# UNITED STATES PATENT AND TRADEMARK OFFICE

APPLICATION NO.	FILING DATE	FIRST NAMED INVENTOR	ATTORNEY DOCKET NO.	CONFIRMATION NO.
10/812,993	03/31/2004	Hideki Kuwajima	43890-672	6416

# Office Action Summary

## **DETAILED ACTION**

【8】

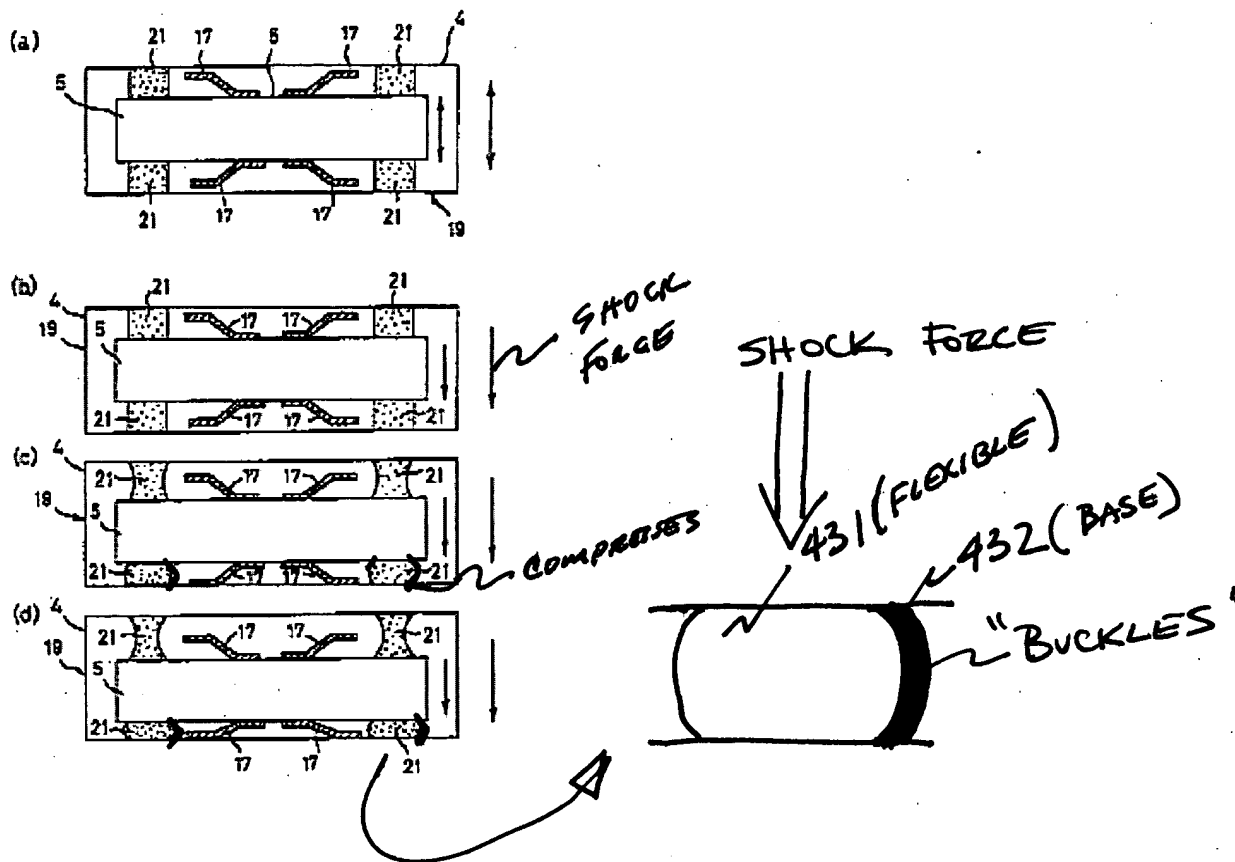
Regarding claims 1, 5, 6, 8, 12, 13 and 20, Yamamura discloses a shock-absorbing member 21 disposed on a main body of electronic equipment (i.e., disk drive) [Fig. 8] and comprising a shock-absorbing flexible part [shown but not numbered].

When subjected to compressive loading, i.e., shock/impact, the shock absorbing member of Yamamura and Ohnishi will absorb a shock when receiving an impact and the shock-absorbing base part will buckle [see annotated Fig. 8].
